| Model: BL-P1a | Date: 05-Jul-11 | No.: RM087001 |

| Subject: Firmware Release Note: Engine Firmware(Package) | | Prepared by: Y. Gaman | |

| Model: BI-P1 | | Date: 4-Jun-18 | No.: RM087004 |
| Subject: Parts Catalog Correction: Front Chute Assy | | Prepared by: T. Tachibana | |

6.Frame Section (M087/M088)

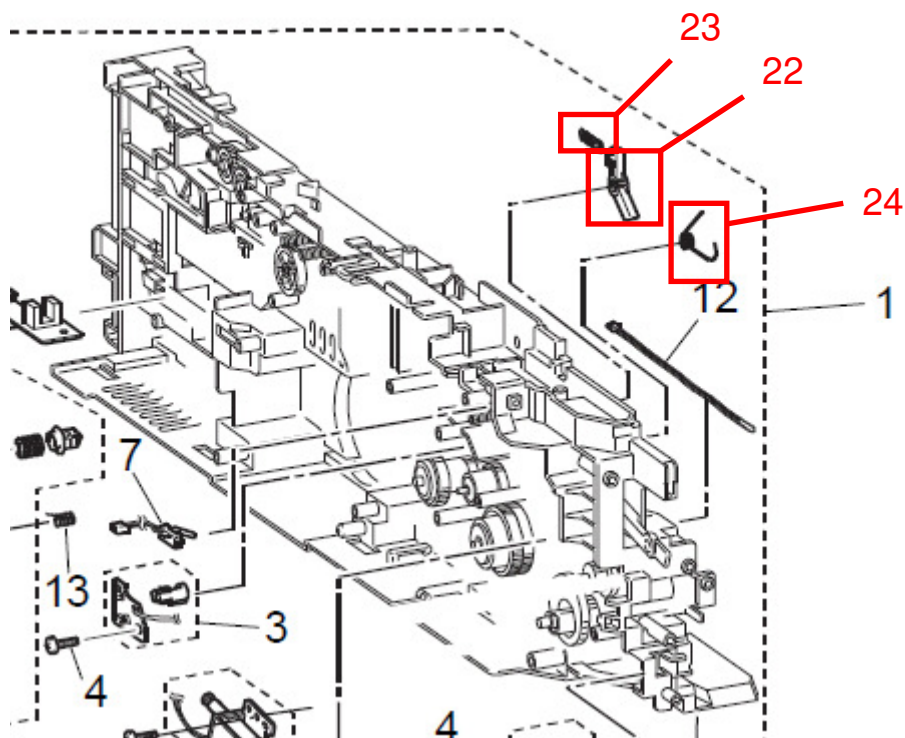
Change: The parts is newly added.

Reason: To meet requests received from the field.

| Old part number | New part number | Description | Q'ty | Int | Page | Index | Note |
|-----------------|-----------------|------------------|------|-----|------|-------|------|
| | M0859500 | FRONT CHUTE ASSY | 0-1 | - | 13 | 26 | |
